## APPENDIX B

### Summary of DRA Analysis of Late-Filed ALJ Exhibits

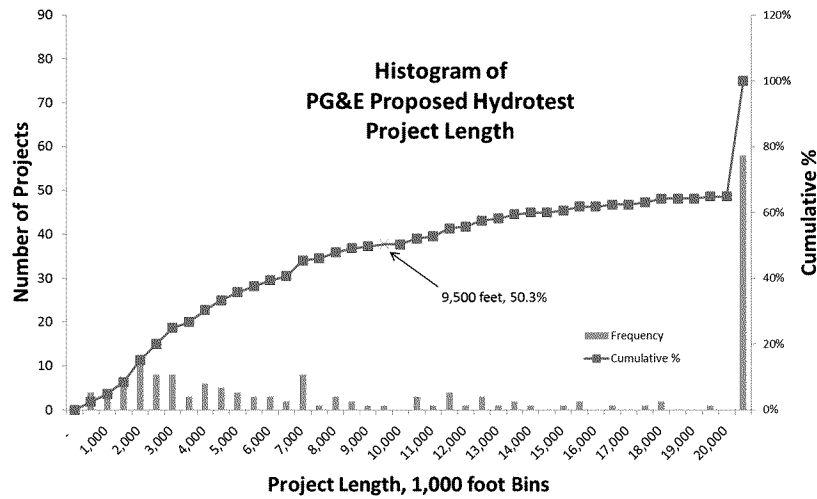
In addition, the record shows that hydrotest costs per foot decrease with increased length of a project, as fixed costs are spread over a larger length of pipe. The following chart shows hydrotest costs per foot for PG&E’s 165 proposed hydrotests projects, as a function of the length of each project:

This chart shows that short test projects, including all those shorter than 10,000 feet, have a cost per foot higher than \$95.8.

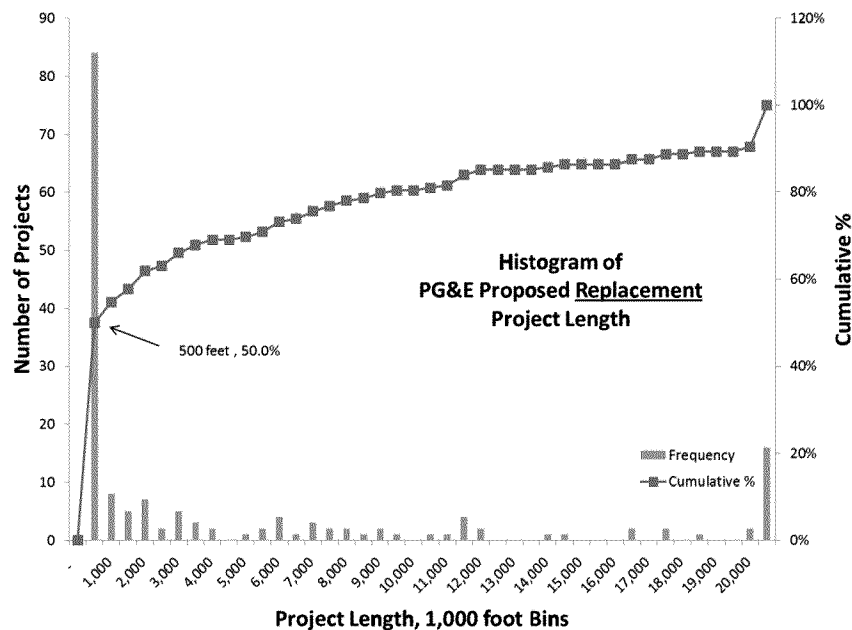
histogram of the 165 hydrotests shows the number of tests (y axis) within each project length bin (x axis):<sup>11</sup>

This chart shows that approximately 2/3 of the *hydrotest* projects are longer than a mile, and 58 projects are longer than 20,000 ft. These long projects, which have a low cost per foot as shown above, drive the average cost per foot used in the PD.

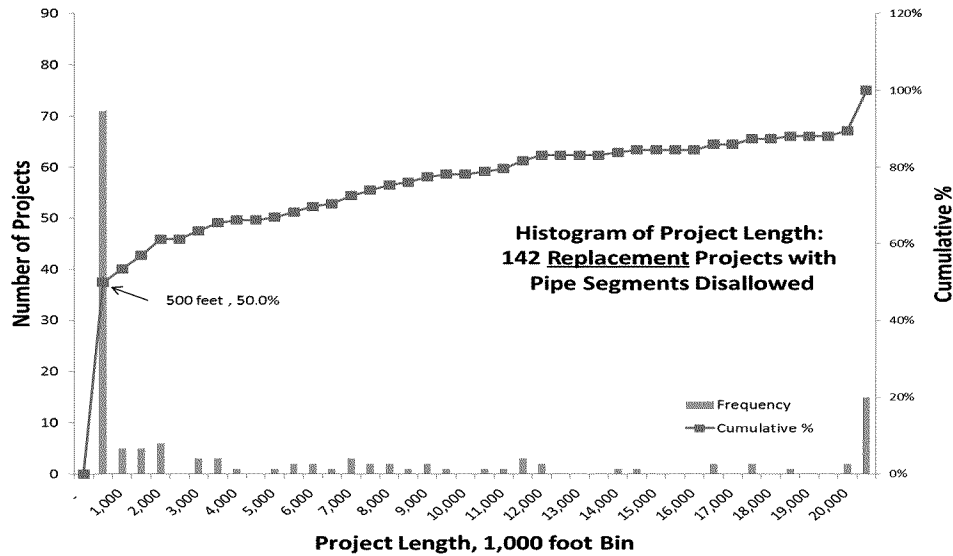
In comparison, the median length of PG&E’s proposed *replacement* projects is 509 feet, over 17 times less than the median length of *hydrotest* projects:<sup>12</sup>

This chart shows that the majority of proposed *replacement* tests (84 of 168) are less than 1,000 feet long.
